Discussion on “AC Drive Observability Analysis”

In the paper by Vaclavek *et al.* (*IEEE Trans. Ind. Electron.*, vol. 60, no. 8, pp. 3047-3059, Aug. 2013), the local observability of both induction machine and permanent magnet synchronous machine under motion sensorless operation is studied. In this letter, the “slowly varying” speed assumption is discussed, and the permanent magnet synchronous machine observability condition at standstill is revisited.

Fig. 1. Vector diagram of the fictitious observability vector (dashed).

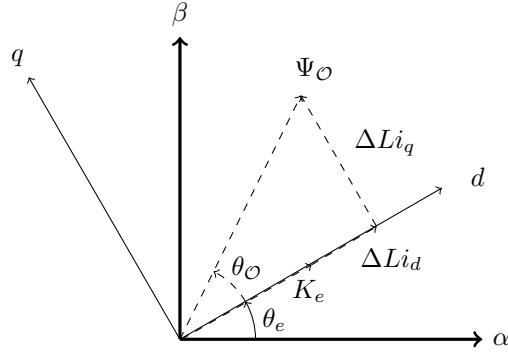
where θ_O is the phase of the vector Ψ_O in the rotating reference frame (Figure 1). The following sufficient condition for the PMSM local observability can be stated:

Proposition 1: The PMSM is locally observable if the angular speed of the fictitious vector Ψ_O in the dq reference frame is different from the rotor electrical angular speed in the stator reference frame.

At standstill, the above condition becomes: the vector Ψ_O should change its orientation in order to ensure the local observability. This provides a better formulation of the PMSM observability conditions.

Fig. 2. Vector diagram illustrating two observability vectors that correspond to two stator current space vectors that differ in magnitude and direction.

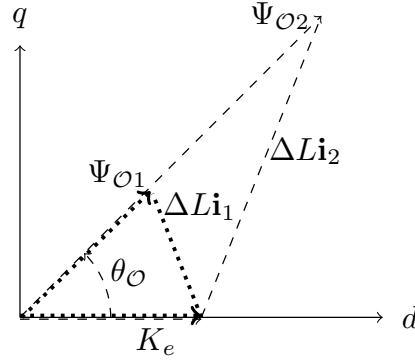
Figure 2 shows two observability vectors, Ψ_{O1} (dotted) and Ψ_{O2} (dashed), that correspond to two different (in magnitude and direction) current space vectors:

It is obvious that, contrary to the conclusion drawn in [1] for the IPMSM, at standstill ($\omega_e = 0$), the stator current space vector can change both its magnitude and direction, following the constant- θ_O trajectory, without fulfilling the observability condition (8). It should be noticed that this is related to the constant C of the equation (3), which value is judged to be unnecessary in the paper under discussion.
